QUALITY ASSURANCE -- NON-CONFORMANCE REPORT

Report No: NCR-000737

Reference Description: Buttering of the flange surfaces of 2 Traveler Rails for thickness build-up

Job Name: SAS Superstructure

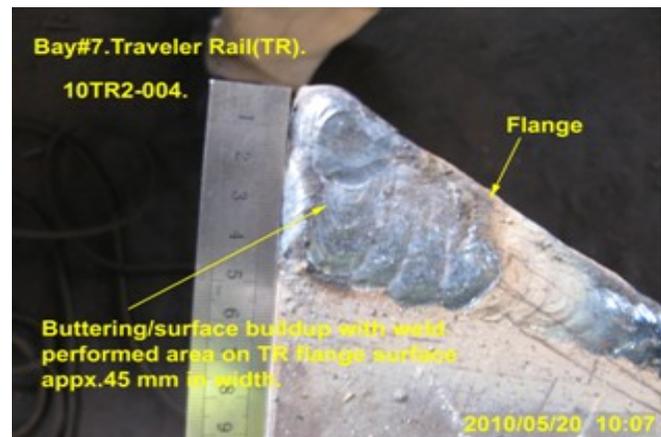
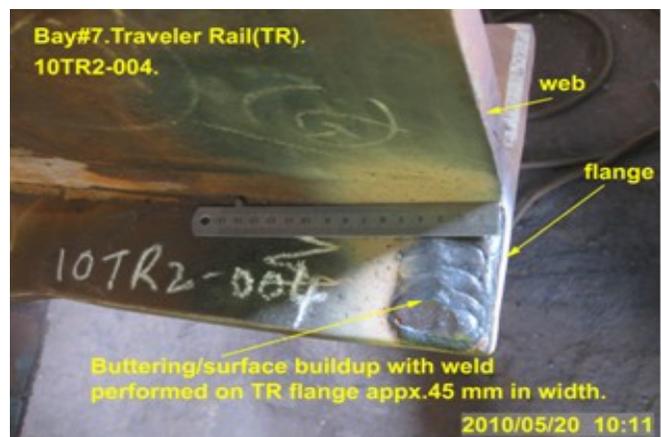
During the Quality Assurance (QA) random in-process visual inspection of Orthotropic Box Girder (OBG) Traveler Rails, this QA inspector discovered the following issues:

- ZPMC welding personnel were buttering (build up weld) on the existing base metal surfaces for thickness build-up.
- The work prescribed above was performed without prior Engineer's approval.
- The affected Traveler Rails are identified as: 10TR3-006 and 10TR2-004.
- The repair area is located on the Traveler Rail flanges.
- Welding process used was Shielded Metal Arc Welding (SMAW).
- The material is A709 Grade 345.
- OBG Traveler Rails are located in the Bay 7.

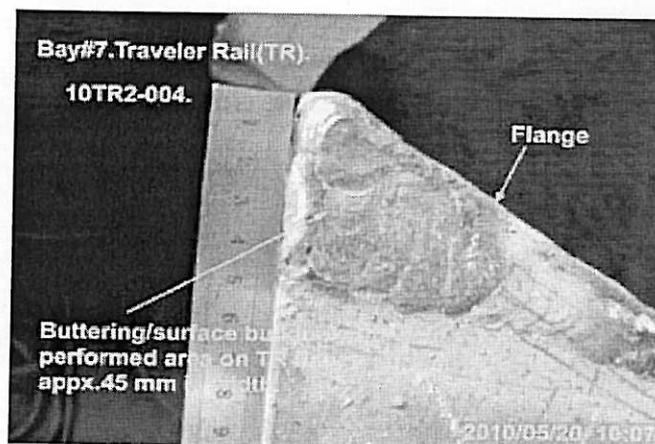
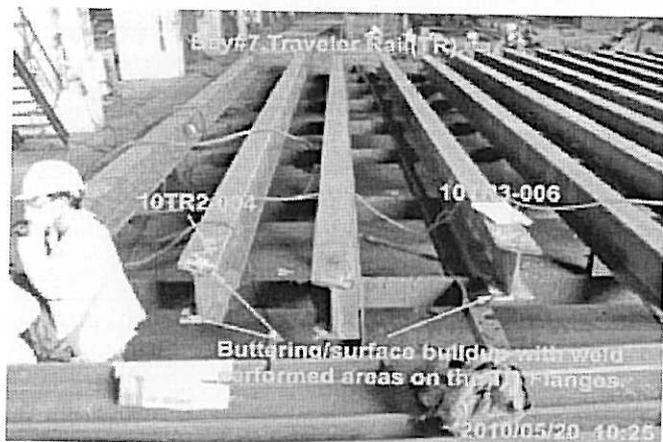
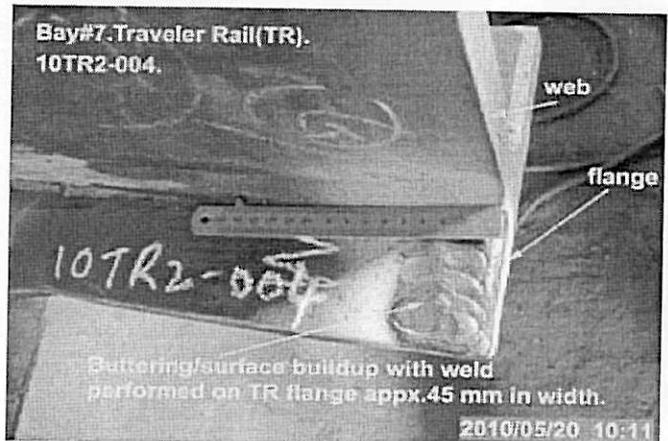
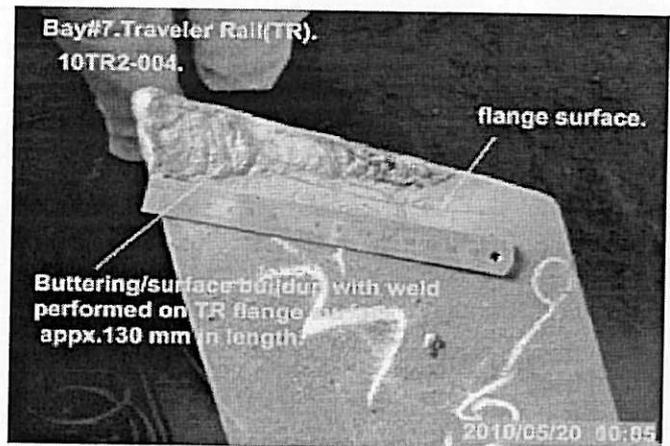
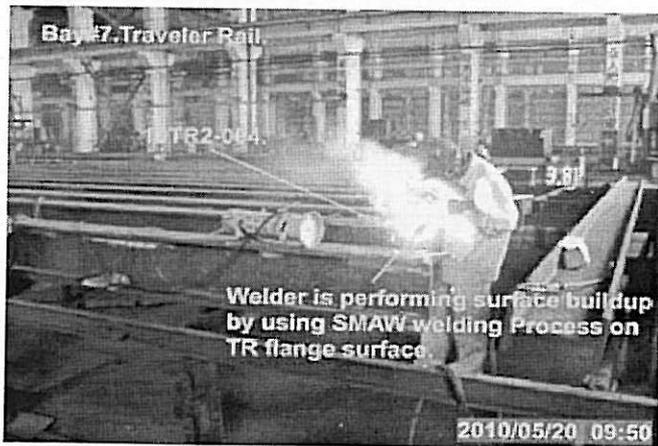
During the Quality Assurance (QA) random in-process visual inspection of Orthotropic Box Girder (OBG) Traveler Rails, this QA inspector discovered the following issues:

-ZPMC welding personnel were buttering (build up weld) on the existing base metal surfaces for thickness build-up.

-The work prescribed above was performed without prior Engineer's approval.

-The affected Traveler Rails are identified as: 10TR3-006 and 10TR2-004.

-The repair area is located on the Traveler Rail flanges.

-Welding process used was Shielded Metal Arc Welding (SMAW).

-The material is A709 Grade 345.

Critical Welding Repair Report (CWR)

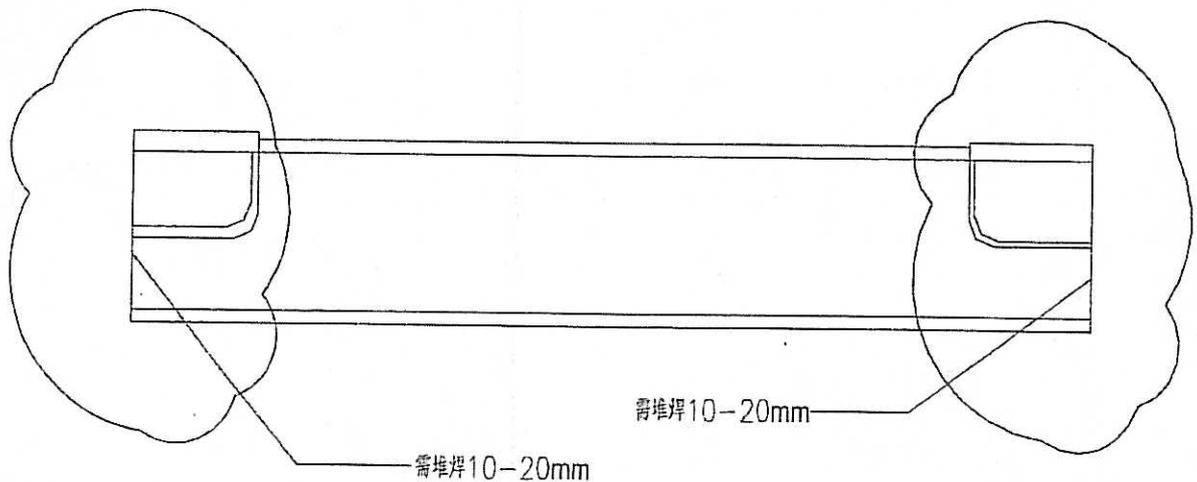
Maintenance travel way fabricated by work team: Zhen Xizhi, part No, 10TR1 (005.007.009.012.014).10TR2(003.004.006.007.008.021).10TR3(003.004.006.026). 11TR1 (016). 11TR3 (005.006.007.009.010.011.012.013.017.018.020.021.022.025). the size was 15-27mm shorter than drawing requirement after welding and needed to build up.

1. 腹板堆焊之前先对法兰堆焊。
 2. 这次返修时, QC和Leader CWI到现场对打磨, 焊接进行指导和监控工作以保证返修按照处理意见进行;
 3. 整个返修的过程, QC和Leader CWI应该有批准CWR的复印件;
 4. 准备一个正确的接头型式, 具体参照相应的返修WPS;
 5. 清理焊接区域, 并进行100%的VT;
 6. 贴钢衬垫, 根据批准的返修焊接工艺规程(WPS)进行预热及焊接;
 7. 去除钢衬垫, 将修补焊缝打磨至与周围母材平齐;
 8. 对修补区域作100%VT, MT和UT检测;
-
1. Perform buttering on flanges prior to buttering web.
 2. QC and a Lead CWI shall be present, direct and supervise all grinding and welding operations during this repair to ensure the repair is per the disposition requirements
 3. QC and a Lead CWI shall have an approved copy of the CWR in hand prior to the repair.
 4. Prepare excavation according to the approved repair WPS.
 5. Clean area and perform 100%VT.
 6. Add steel backing , preheat and weld according to the relevant repair WPS.
 7. Remove the steel backing and grind the weld flush with around metal;
 8. Perform VT, MT and UT over 100% of the repair area.

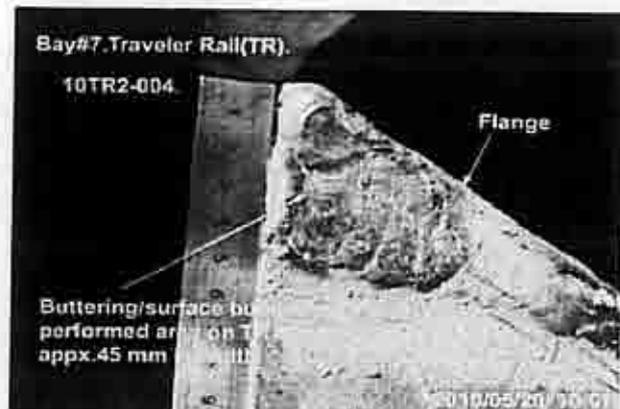
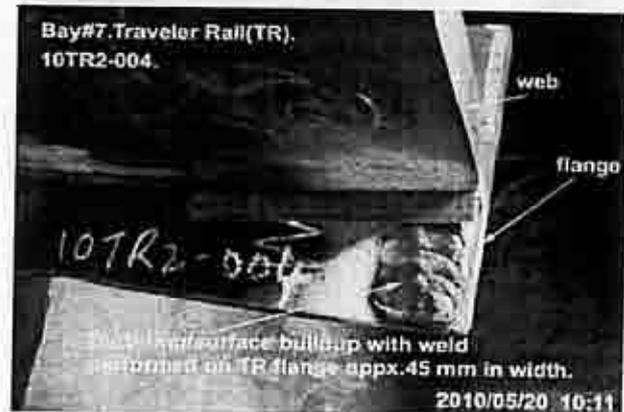
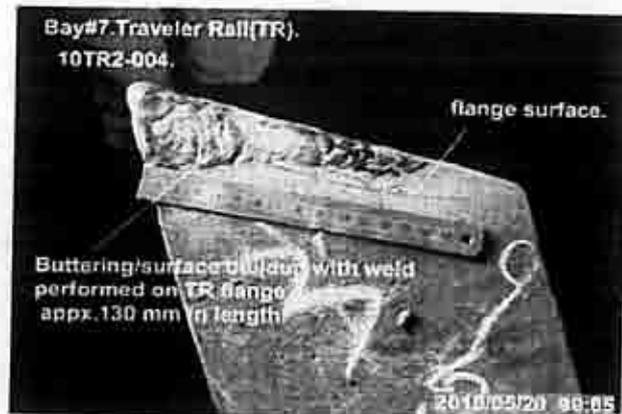
During the Quality Assurance (QA) random in-process visual inspection of Orthotropic Box Girder (OBG) Traveler Rails, this QA inspector discovered the following issues:

- ZPMC welding personnel were buttering (build up weld) on the existing base metal surfaces for thickness build-up.
- The work prescribed above was performed without prior Engineer's approval.
- The affected Traveler Rails are identified as: 10TR3-006 and 10TR2-004.
- The repair area is located on the Traveler Rail flanges.
- Welding process used was Shielded Metal Arc Welding (SMAW).
- The material is A709 Grade 345.
- OBG Traveler Rails are located in the Bay 7.

Welding Repair Report

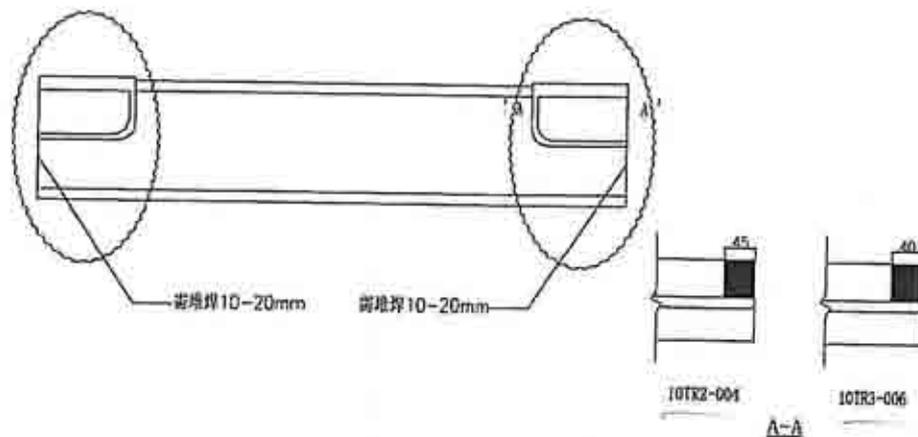
Maintenance travel way fabricated by work team: Zhen Xizhi, part No, 10TR1 (005.007.009.012.014).10TR2(003.004.006.007.008.021).10TR3(003.004.006.026). 11TR1 (016). 11TR3 (005.006.007.009.010.011.012.013.017.018.020.021.022.025). the size was 15-27mm shorter than drawing requirement after welding and needed to build up.

BUTTER FLANGE END TO BUILD UP LENGTH ,BUTTER FLANGE SURFACE TO BUILD UP THICKNESS .

1. QC and a Lead CWI shall be present, direct and supervise all grinding and welding operations during this repair to ensure the repair is per the disposition requirements
2. QC and a Lead CWI shall have an approved copy of the CWR in hand prior to the repair.
3. Prepare excavation according to the approved repair WPS.
4. Grind the repaired area to a smooth and shiny finish, with tapered ends, to ensure staggered starts and stops.
5. VT and MT the repair area.
6. Add steel backing , preheat and weld according to the relevant repair WPS.
7. Remove the steel backing and grind the weld flush with around metal;
8. Perform VT and MT over 100% of the repair area.

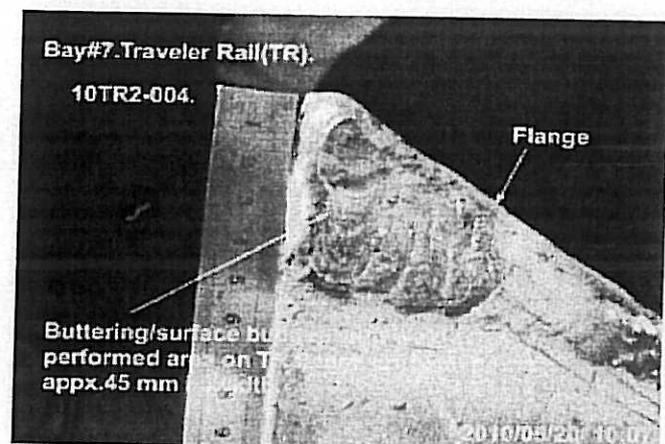
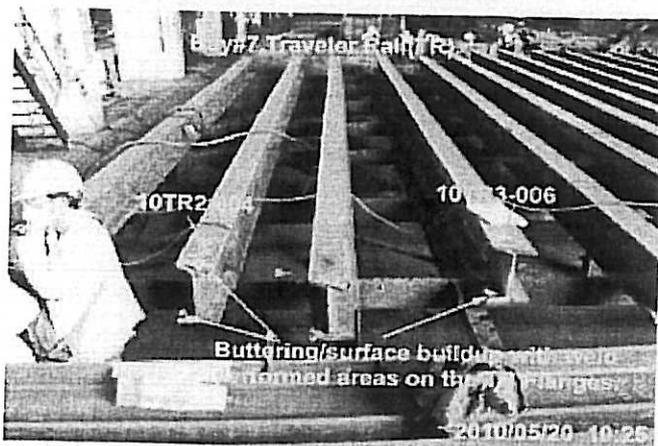
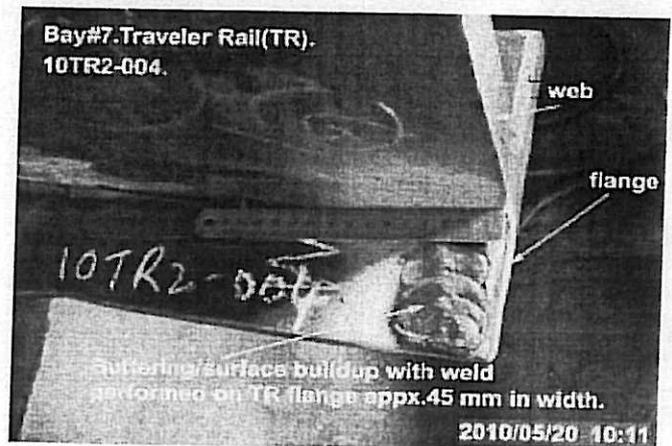
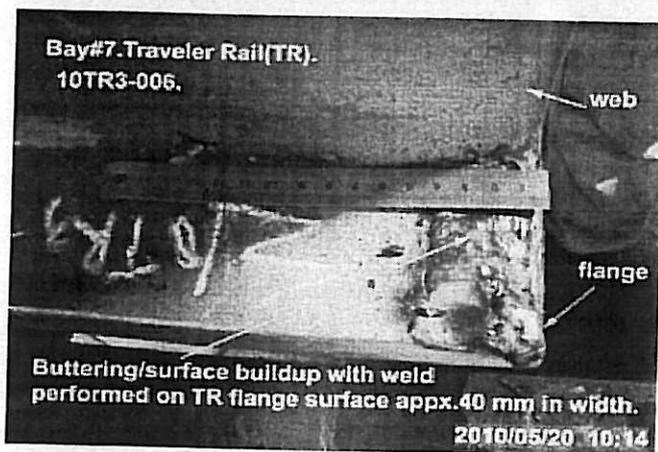
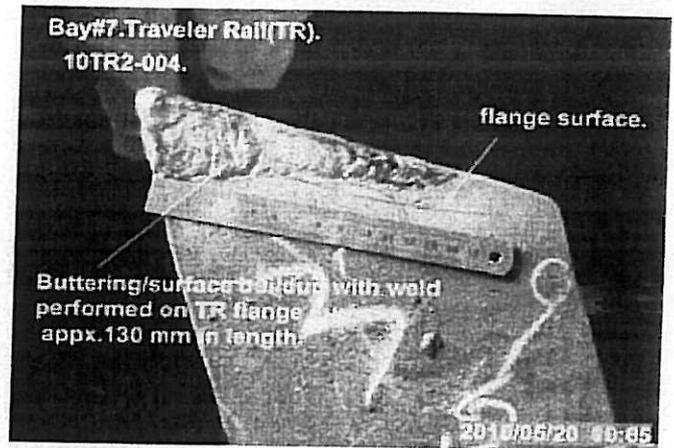
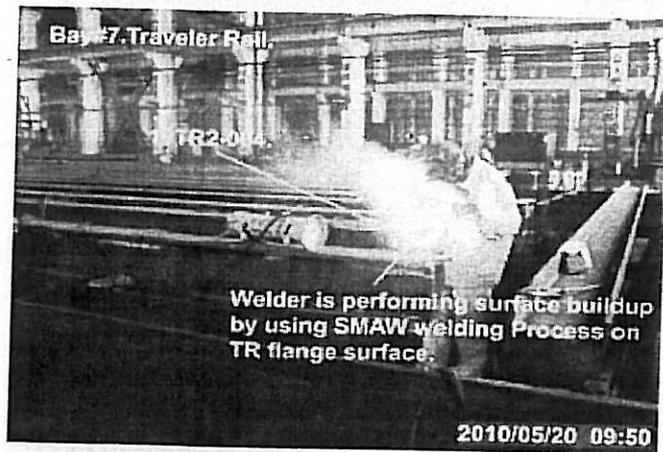
Reference Description: Buttering of the flange surfaces of 2 Traveler Rails for thickness build-up

- ZPMC welding personnel were buttering (build up weld) on the existing base metal surfaces for thickness build-up.
- The work prescribed above was performed without prior Engineer's approval.
- The affected Traveler Rails are identified as: 10TR3-006 and 10TR2-004.
- The repair area is located on the Traveler Rail flanges.
- Welding process used was Shielded Metal Arc Welding (SMAW).
- The material is A709 Grade 345.
- OBG Traveler Rails are located in the Bay 7.
